Access Compliance Report

Public Rights-of-Way

(Curb Ramps)

Intersection ID: 19953	Main Street: ARCHDALE_DR	Cross Street: OLD_PINEVILLE_RD	Location: NW
ADA ID: 56104E2F9869	Ramp Type: Perp	Initial Pass/Fail: Fail	Overall Compliance: No
Severity Score: 21.25			
Codes/Mitigation Info/Possible Solution		Field Measurements/Component Compliance

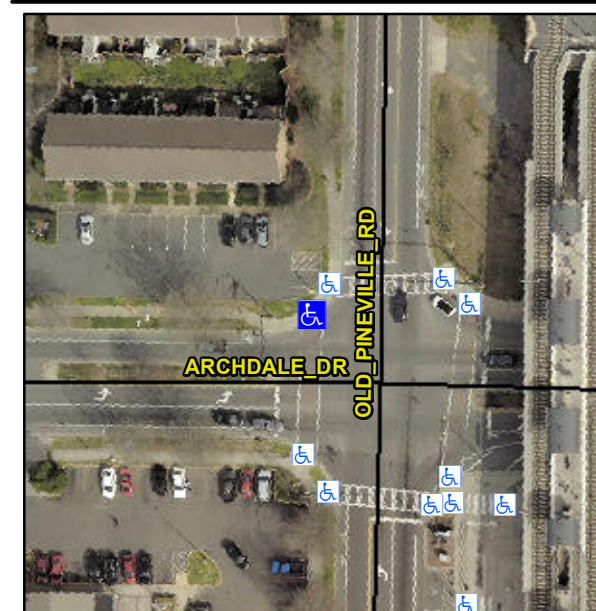
Remove & Replace Entire Ramp.

Not Found, R304.5.1, R304.5.3

Compliance	Description	Data	Compliance	Description	Data
N/A	Ramp Length (in)	72.0	Yes	Ramp Slope (%)	6.1
No	Ramp Width (in)	45.0	No	Ramp XSlope (%)	5.2
N/A	Flare Type LT	N/A	N/A	Flare Type RT	N/A
N/A	Flare Slope LT (%)	N/A	N/A	Flare Slope RT (%)	N/A
N/A	Flare Traversable LT?	N/A	N/A	Flare Traversable RT?	N/A
N/A	Landing Length (in)	N/A	N/A	DWS Provided?	N/A
N/A	Landing Width (in)	N/A	N/A	DWS Contrast?	N/A
N/A	Landing Slope (%)	N/A	N/A	DWS Length (in)	N/A
N/A	Landing X Slope (%)	N/A	N/A	DWS Full Width?	N/A
N/A	Landing Curb? (Y/N)	N/A	N/A	DWS Offset (in)	N/A
N/A	Shared Landing?	N/A			
N/A	Gutter Ponding?	N/A	N/A	Gutter Slope (%)	N/A
N/A	Gutter Lip Ht (in)	N/A	N/A	Gutter X Slope (%)	N/A
N/A	Painted X Walk1?	Yes	N/A	Painted X Walk2?	N/A
	X Walk 1 Direction	To SW		X Walk 2 Direction	N/A
N/A	X Walk 1 Width (in)	122.0	N/A	X Walk 2 Width (in)	N/A
	X Walk 1 Slope (%)	0.8		X Walk 2 Slope (%)	N/A
	X Walk 1 X Slope (%)	4.5		X Walk 2 X Slope (%)	N/A
